## GE Consumer & Industrial

## Service Bulletin

HL02-10

MODELS: DLSR483EG/GG, DWSR483EG/GG, DWXR483EG/GG, DBSR463EG/GG, DBXR463EG/GG, DJXR433EG/GG

Start switch and control panel example

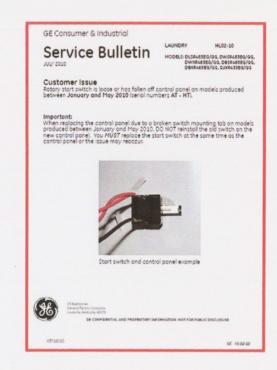
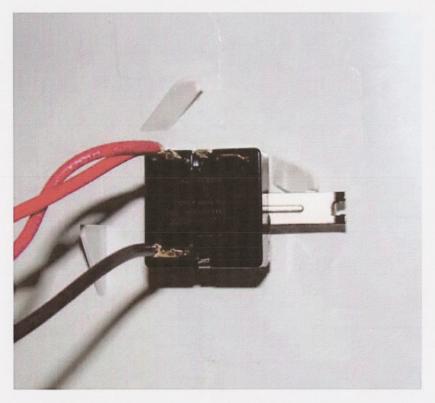
Rotary start switch is loose or has fallen off control panel on models produced between **January and May 2010** (serial numbers **AT - HT**).

When replacing the control panel due to a broken switch mounting tab on models produced between January and May 2010, DO NOT reinstall the old switch on the new control panel. You <u>MUST</u> replace the start switch at the same time as the control panel or the issue may reoccur.
